**Re: Site Plan Review
55 Constitution Boulevard
Site Plan Application**

BETA Group, Inc. is pleased to provide engineering peer review services for the proposed project entitled “**55 Constitution Boulevard**” located in Franklin, MA. This letter is provided to update our findings, comments, and recommendations.

BETA reviewed this project previously and provided review comments in letters to the Planning Board dated December 11, 2024 (*original comments in italics*). Beals Associates, Inc. (BAI) has provided responses (responses in standard text) to all the comments except those related to **Stormwater Management**. This letter provides BETA’s response to each (*latest status in bold italics*).

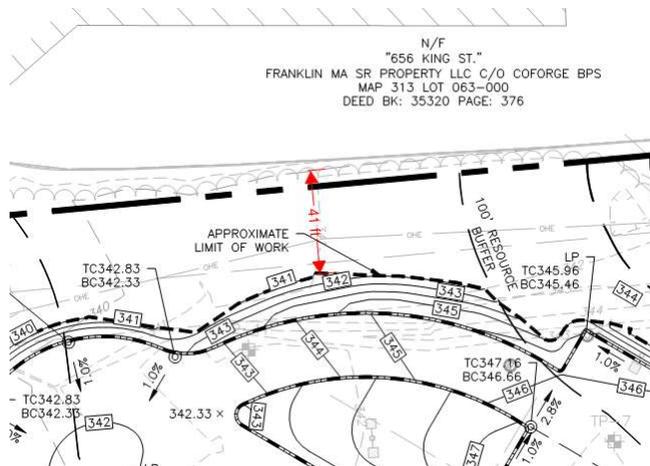
LA1. Provide required screening for the loading docks and parking areas associated with Building B. Based on BETA's site observations, the residential buildings at #648 and #656 King Street are readily visible from the existing Site, and proposed tree clearing will further reduce the vegetated area (§185-35.A).

BETA2: To the west BETA agrees that 40'± of existing vegetation will remain. However, the berm that exists presently along the 50' protective covenant setback will be impacted by the proposed access driveway as shown in the sketch above. In addition, based on the field visit, BETA noted that both the Assisted Living Facility and the residence to the northwest were readily visible from the site. BETA recommends that the landscape buffer in this area and along the northerly edge of the parcel be converted to a dense evergreen buffer rather than the deciduous trees and shrubs currently specified for further review and discussion by the Board.

As noted in Section B, screening can be accomplished by any of the following: new plantings, a wall, an earthen berm 12” or more in height, or equivalent visual screening by natural vegetation, or difference in elevation between potential viewers and the screened areas. Furthermore, as noted in Section C, for an industrial project such as this less than 500 feet from a residential use, a greenbelt not less than 15 feet wide containing a dense grouping of trees and shrubs providing a natural barrier between the lot and the premises must be provided.

As documented in the screenshot to the right, a natural greenbelt buffer approximately 41 feet wide at the narrowest has been provided between the access drive and the edge of the clearing on the adjacent property. As the greenbelt as is almost three times the required natural barrier in the bylaw, BAI believes adequate screening has been provided.
